Series II Fuel Manager® Style Redesign

Baldwin Filters has redesigned its Series II line of fuel filter/water separators. Prior to this design change, the construction of this family of filters included a metallic housing. The new construction utilizes a high-strength polymer housing.

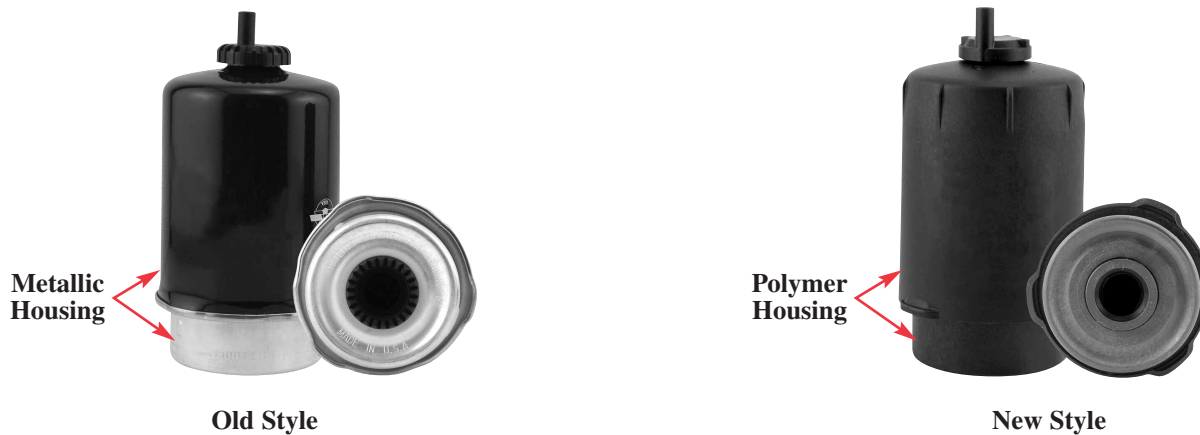
- Tough, durable engineered polymer material, used for the housing, withstands even the worst application environments.
- Conductive, polymer material designed to dissipate static electricity build-up.
- Structural requirements met for all intended applications.
- Consistently tested to several hundred thousand cycles in hydrodynamic impulse testing at application pressures with no leaks.
- Environmentally friendly components (with exception of media pleat clip and wave spring).
- Raised keys eliminated for universal fit on multiple fuel bases.
- Wave spring provides installation resistance for proper fit.
